We are writing on behalf of the Viking Meadows Homeowners Advisory Committee to request the City of Westfield and our elected officials take immediate action to enforce multiple violations we have identified with regard to the PUD Ordinance governing the Viking Meadows Development.

THE MEADOWLANDS AT VIKING MEADOWS SECTION TWO Secondary Plat

THE MEADOWLANDS AT VIKING MEADOWS SECTION THREE
Secondary Plat

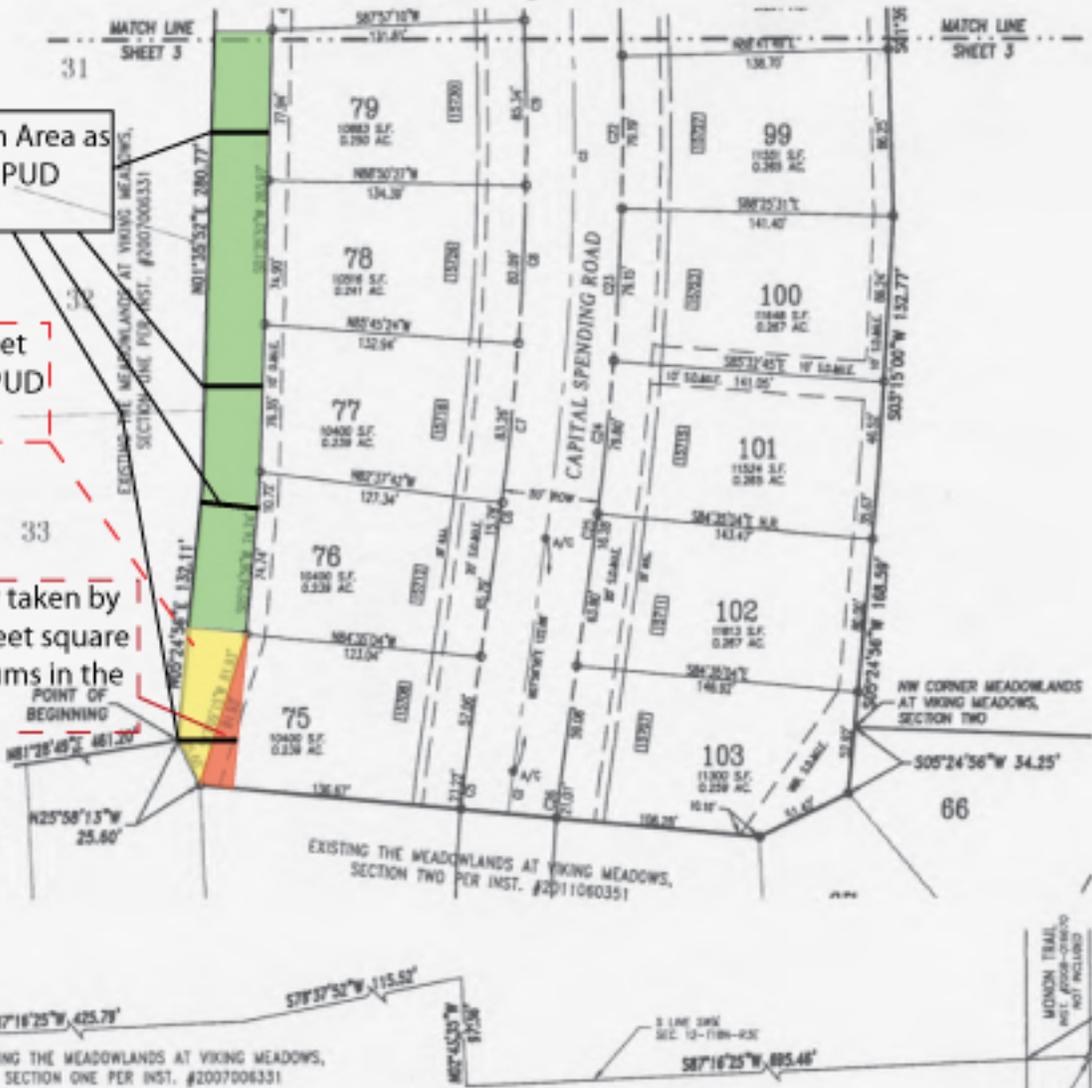
Area fails to meet MINIMUMS of PUD Ordinance.

Area wrongfully taken by developer to meet square footage minimums in the PUD Ordinance.

30' Common Area as required by PUD Ordinance
